<b>ADDENDUM NO. :</b>	<b>Four (4)</b>
<b>BID DUE TIME AND DATE:</b>	2:00 p.m., April 30, 2019 <b>(No Change)</b>
<b>BIDDER QUESTIONS BY:</b>	11:59 a.m., April 23, 2019
<b>LAST ADDENDUM ISSUED:</b>	11:59 p.m., April 25, 2019

**THE PURPOSE FOR THIS ADDENDUM IS:**

- **To provide a response to questions raised by Plan Holders;**
- **To modify/clarify specifications and drawings.**

**A601**

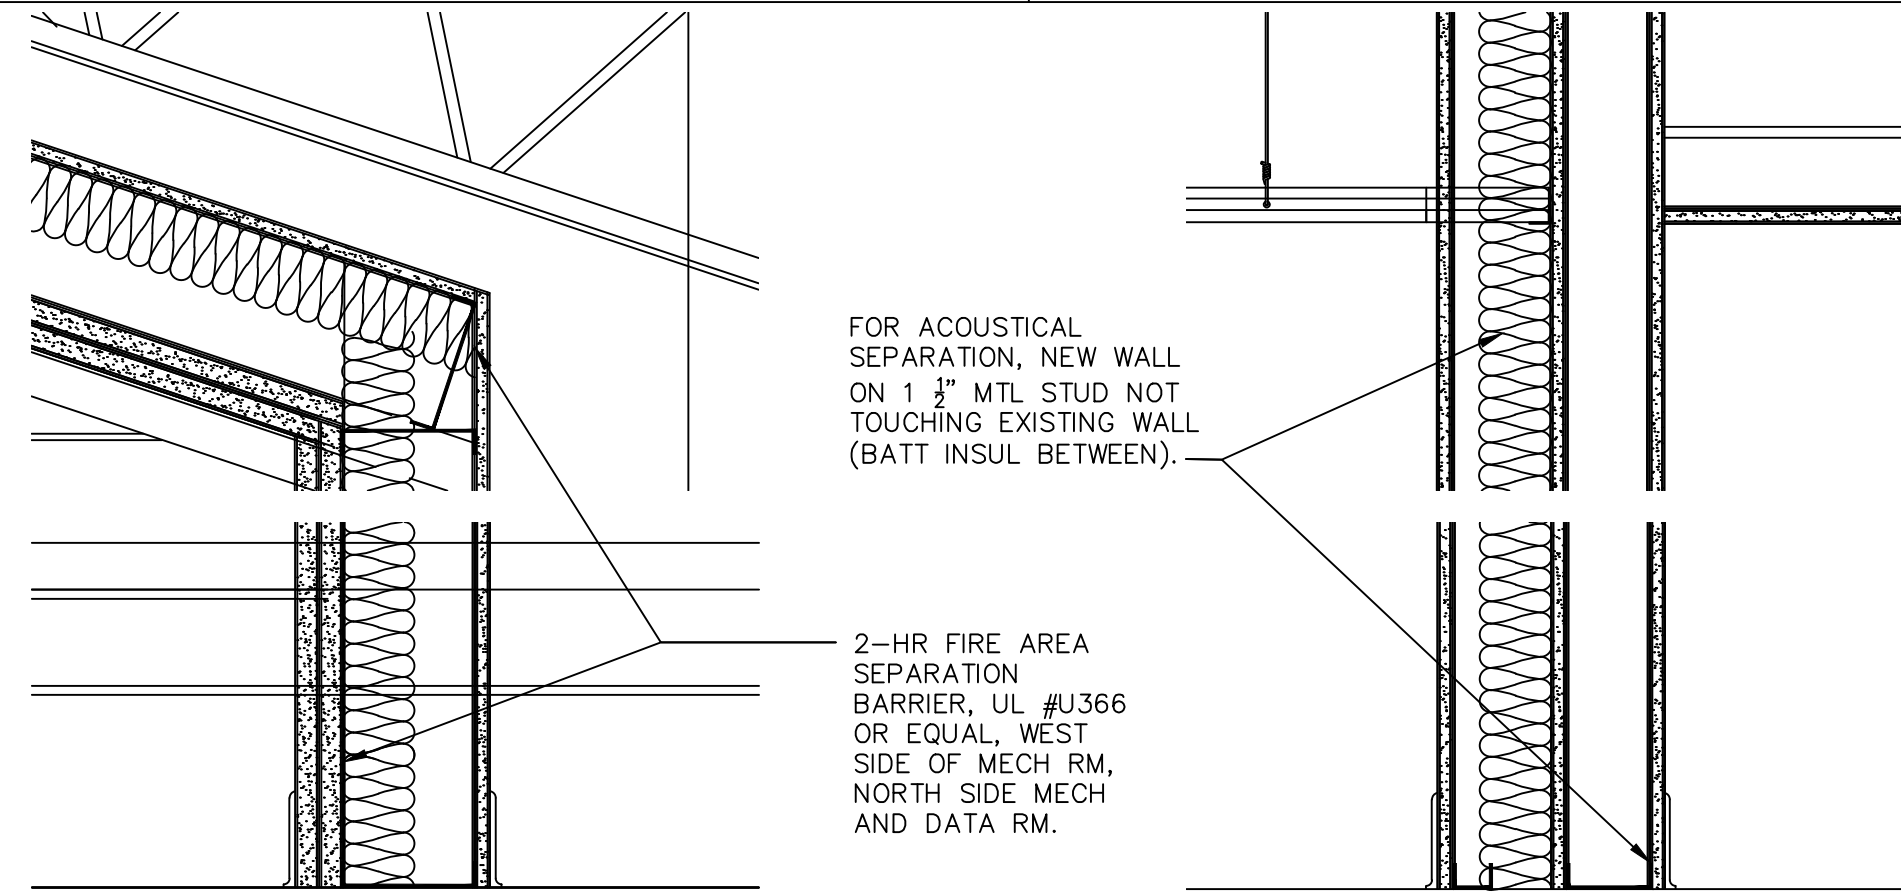
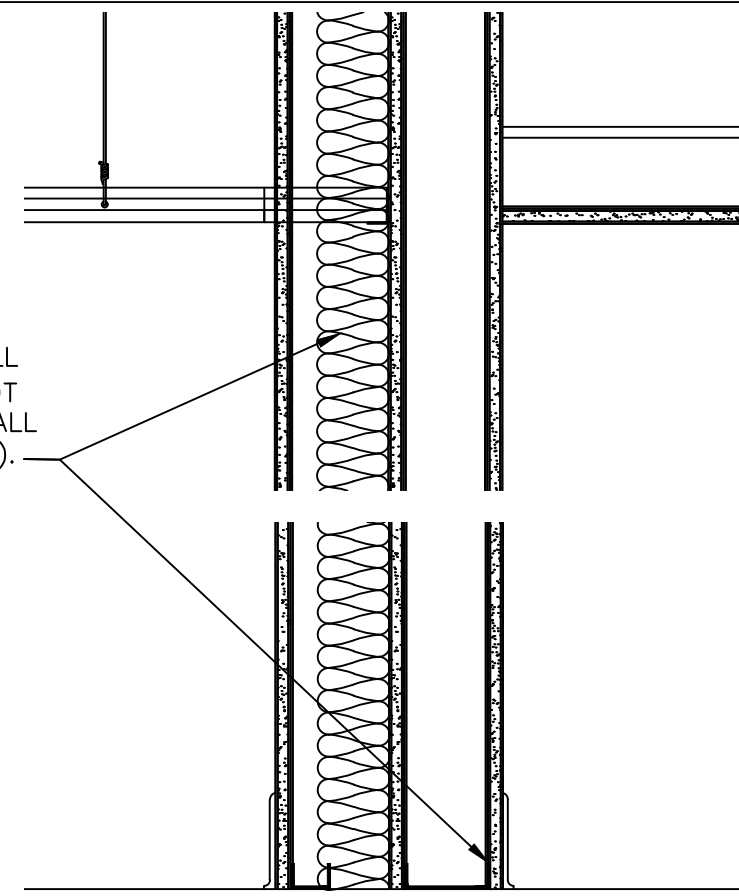
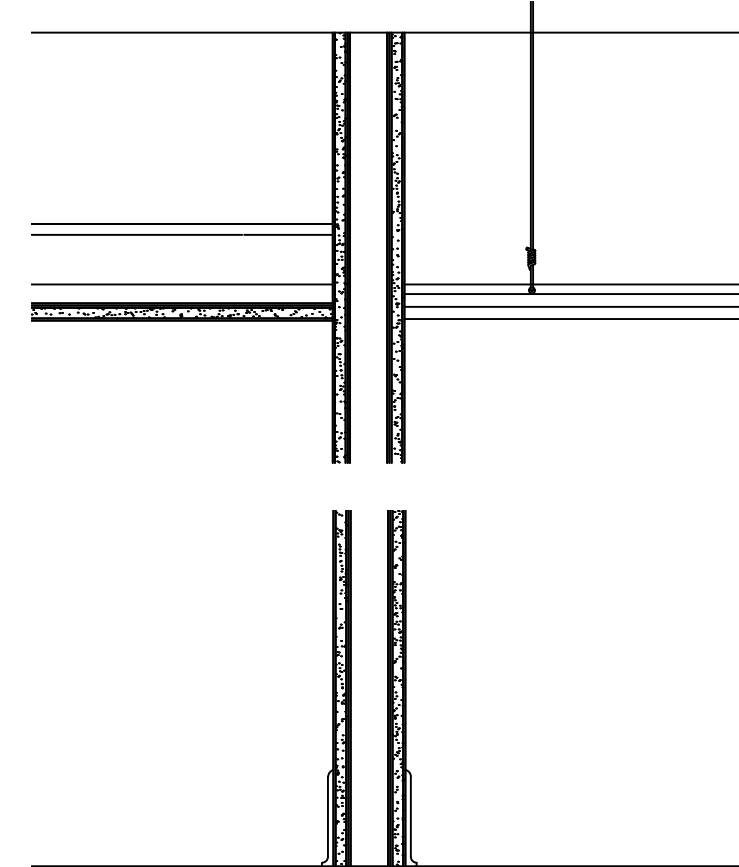
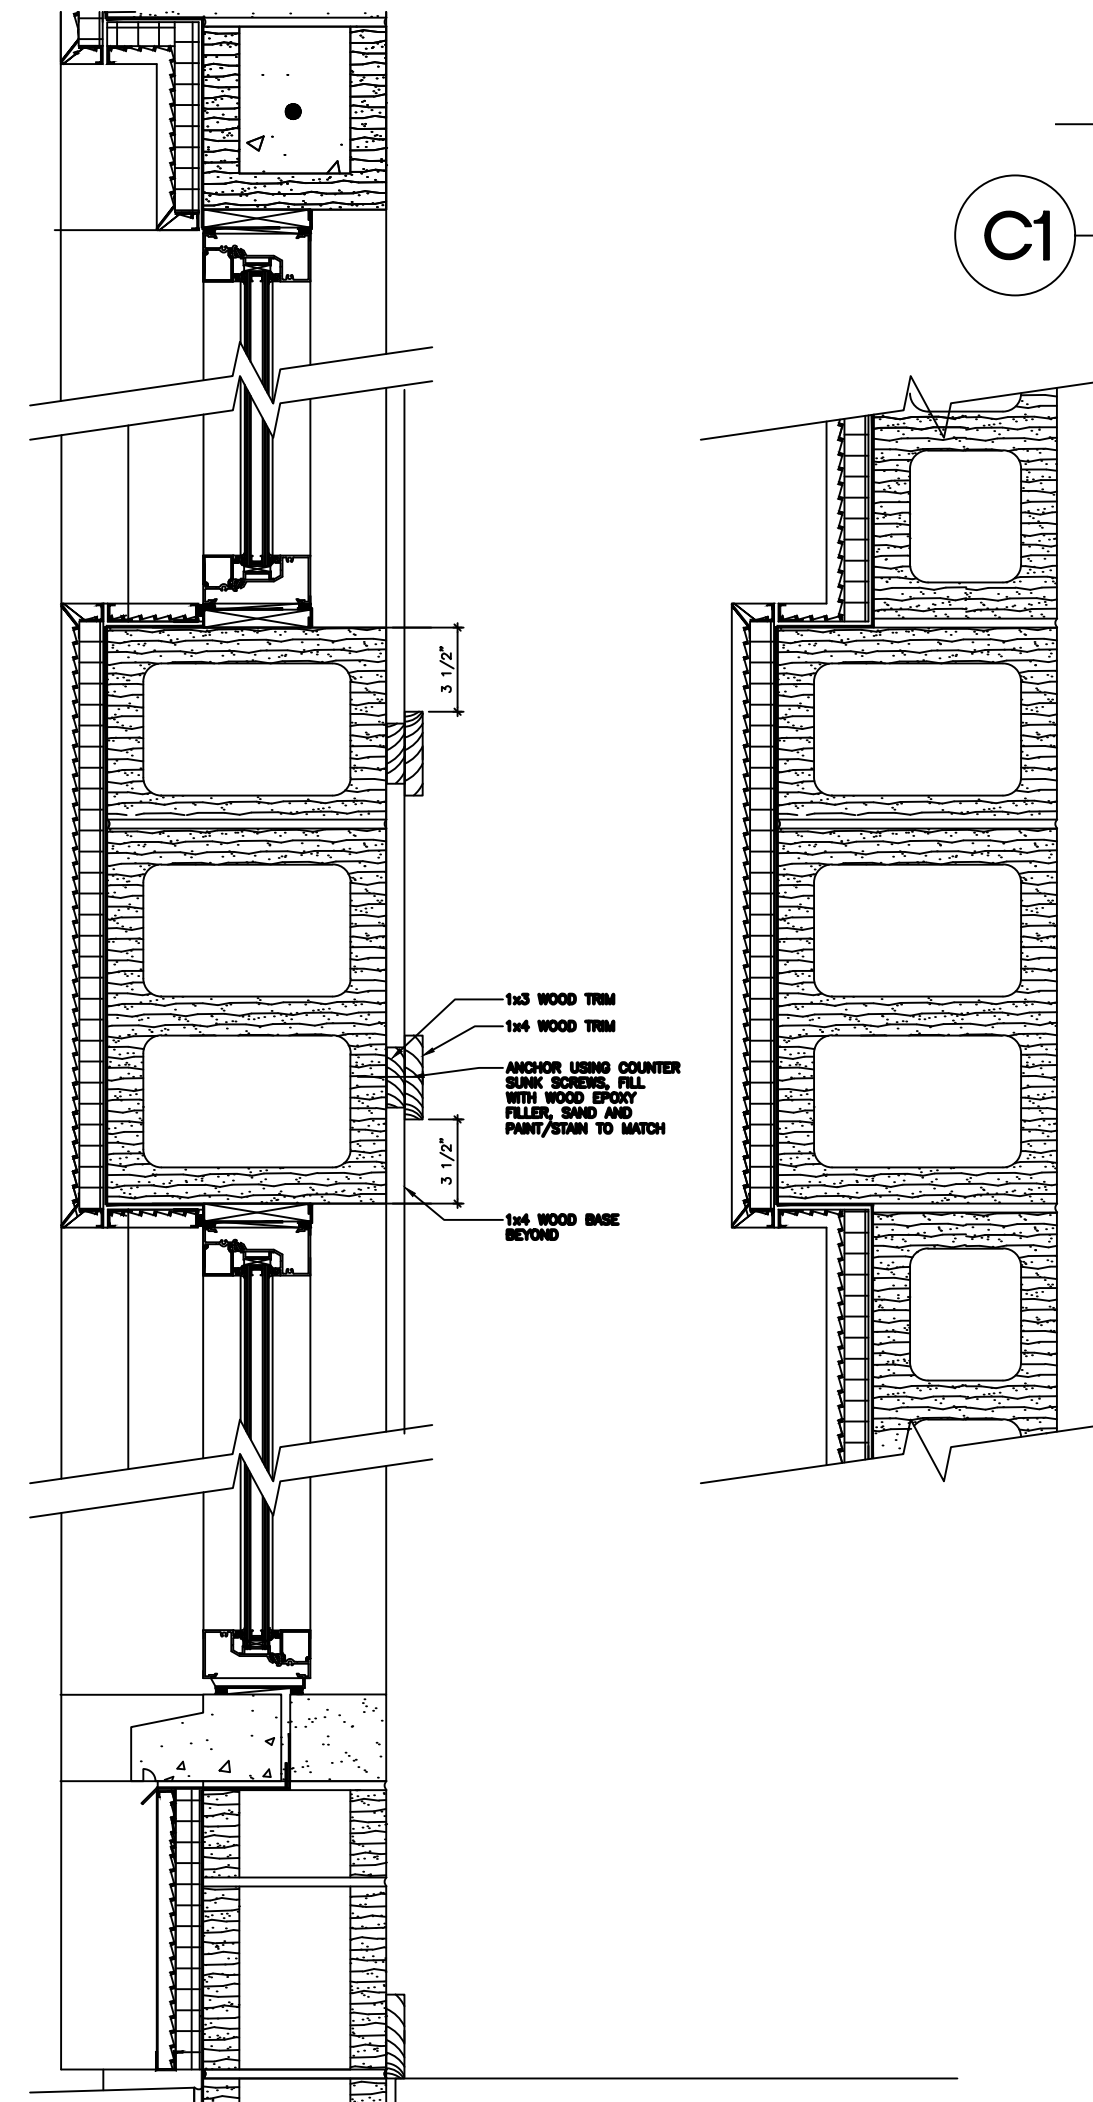
- Clarification on the wall types (section on acoustical separation, 2 hr, and detail at top of 10' wall) and ceiling cloud detail(s) and finish details such intent of columns for exposed electrical on CMU
- HVAC details such as air handler coil connection (what's needed re isolation valves, strainers, etc.)
- Extent of chilled water line treatment
- Specs/detail on OA louver to be installed within storefront (shown on HVAC, visible on Section A301, not A202 or A602)
- Redundancy on, and revisions to a few Hardware items; see hardware Spec sections attached.
- Sections clarified to indicate sill pan, as well as location of drainage barrier; all sections at stucco clarified to show weep at base of drainage plane. Additionally, simplify cast sills.

Accent wall in restrooms at vestibule remain as 3 color tile; similar design provided under Addendum 03 and basis of bid, exact pattern to be provided at a future date.

- A301 Building Sections
- A302 Building Sections
- A303 Ext Wall Sections & Details
- A304 Ext Wall Sections & Details
- A306 Ext Wall Sections & Details
- A502 Ceiling Details
- A601 Finish Schedule w/ Details
- P101, Updated plan to show missing fixtures and missing sanitary and vent piping
- P102, Updated plan to show missing fixtures, missing domestic water piping and missing gas piping
- P101, Updated plan to show missing fixtures and missing sanitary and vent piping
- P201, Updated plan to show missing fixtures and missing sanitary and vent piping
- P202, Updated plan to show missing fixtures, domestic water piping and missing gas piping
- M401, Added detail for chilled water connections to AHU
